The Practice of TSA has been commissioned by Wentworth Point 1 Pty. Ltd. to prepare a traffic and transport impact assessment report to accompany a Section 75W modification to an approved concept plan (MP09\_0160) associated with the redevelopment of land at 23 Bennelong Parkway, Wentworth Point (hereafter referred to as 'Subject Site'). The Section 75W (S75W) modification proposal involves the following amendments:

### 5.3 Response to Traffic Comments provided by Department of Planning, Industry & Environment

**PROPOSED RESIDENTIAL DEVELOPMENT AT  
23 BENNELONG PARKWAY,  
WENTWORTH POINT**

**FIGURE 3**  
**EXISTING PEAK HOUR TRAFFIC VOLUMES**  
**IN THE VICINITY OF THE SITE**

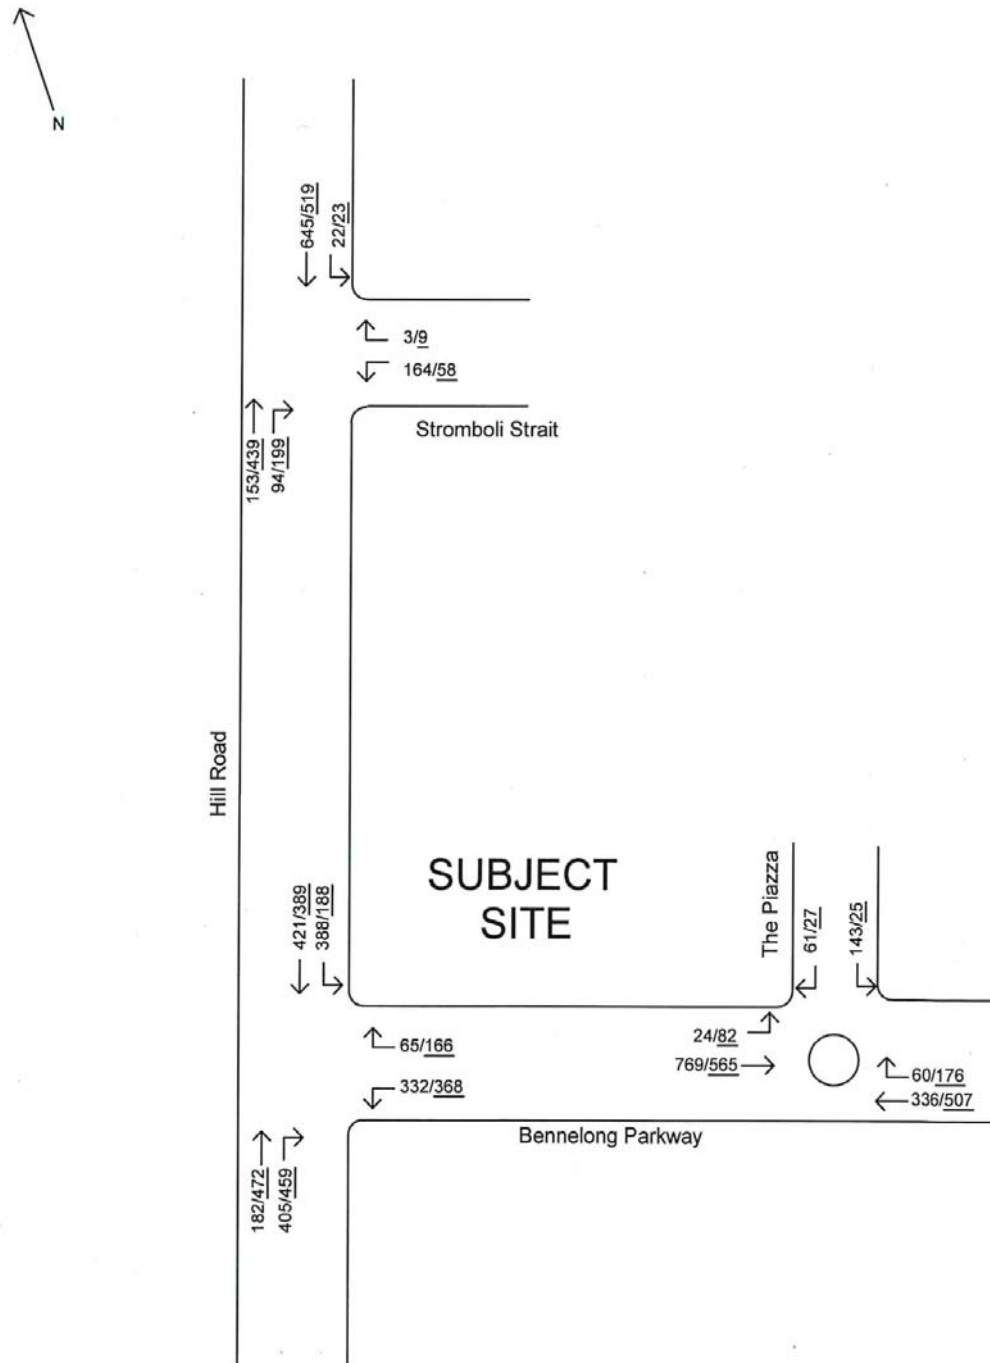
*the date that the updated morning and evening peak hour traffic surveys were undertaken*

Traffic flow surveys were initially undertaken in 31 January 2018 by sub consultants however traffic flows have been regularly observed during various peak hours on a number of occasions during 2019 and 2020. These observations confirm traffic volumes to be similar to that formally recorded in January 2018

**FIGURE 4**  
**PROJECTED SIGNALISED INTERSECTION LAYOUT**  
**JUNCTION OF HILL & BENNELONG PARKWAYS**

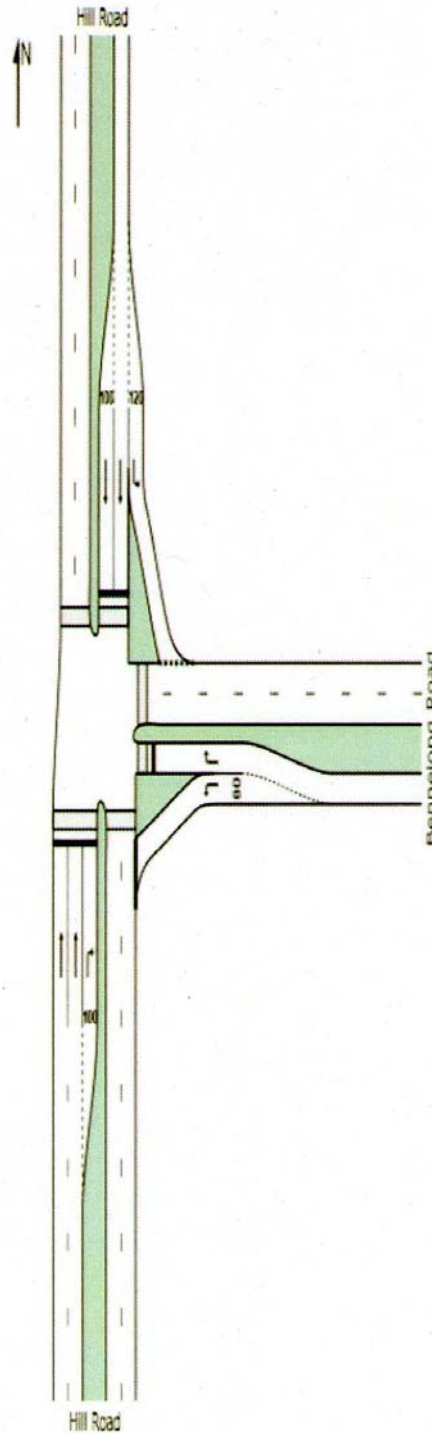
- *further details on the planned upgrade to the Hill Road/ Bennelong Parkway intersection, including what party is responsible for the works and timing, noting the capacity of the road network to accommodate the additional traffic is subject to this road upgrade*

Enquires to Parramatta City Council in recent days has indicated that the design for improved junction traffic management has been commenced with a traffic signal design currently in preparation.

The funding source of this project is under consideration by Council. No date was indicated by Council staff when the installation of the traffic signals would be brought into service

**FIGURE 8**  
**PROJECTED PEAK HOUR TRAFFIC VOLUMES**  
**IN THE VICINITY OF THE SITE INCORPORATING 692 DWELLINGS**  
**ASSOCIATED WITH THE S75W MODIFICATION APPLICATION**

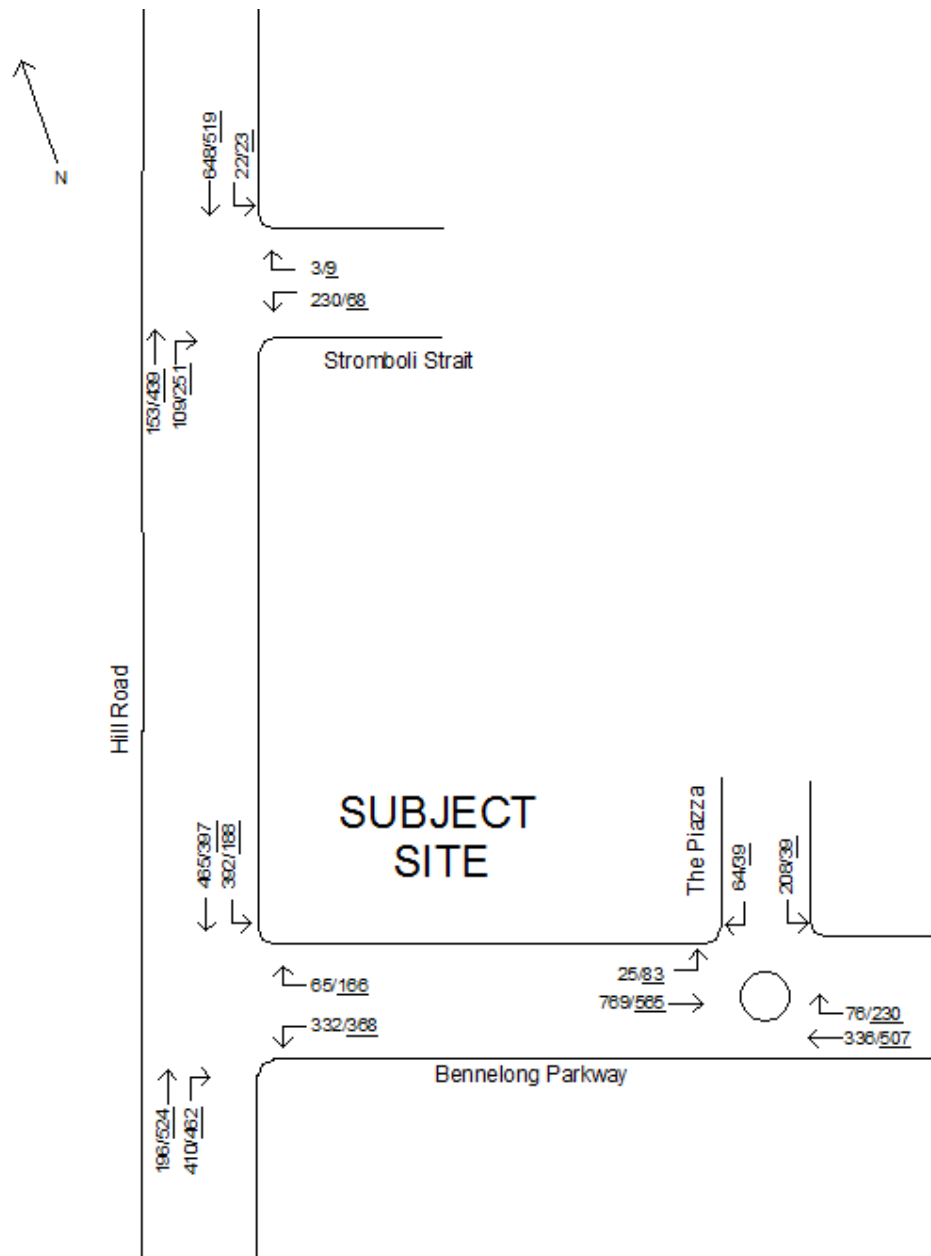
- *consideration of the projected traffic volumes with known approved and under construction developments in Wentworth Point*

*the traffic generation peak hour traffic movements, noting they differ in section 5.1.4 and 5.2.1 of the Traffic Statement Report*

The traffic signals proposed above will service the majority of traffic movements which access the Wentworth Pt precinct via this junction. This includes the existing flows as measured previously as well as those generated under those current residential /mixed use areas under construction and those proposed, including the Piety development, within the precinct.

The traffic generation hourly flows as outlined in section 5.2.1 are the values to be used in the assessment
